| Consultant          | Wahib Medanat Consultant Engineer                   | Rep No.              | 11-04122021  |
| Contractor          | Derar Saraireh & Sons for Engineering & Contracting | Tender No.           | (11/2019/USAID/SKEP/3/S) Schools for a Knowledge Economy Project (SKEP) - Phase (3) Package (1, 2) |
| Site Name           | Um Al Dananir Basic Mixed School- Al Balqa          | Day/ Date            | Sat. 04/12/2021  |

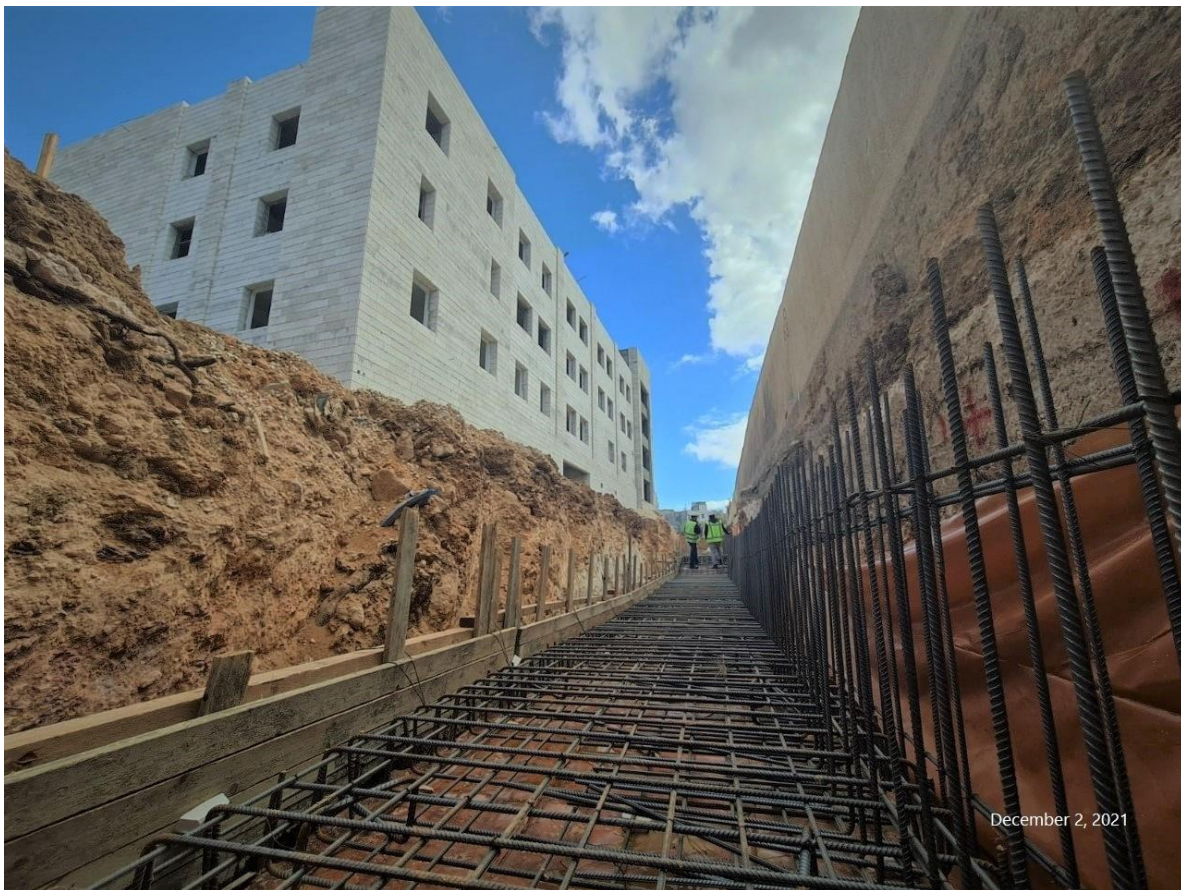
The Engineer presenting the Designer advice to keep the expansion joint as executed without fixing the aluminum cover. The details in the drawings should be taken into consideration
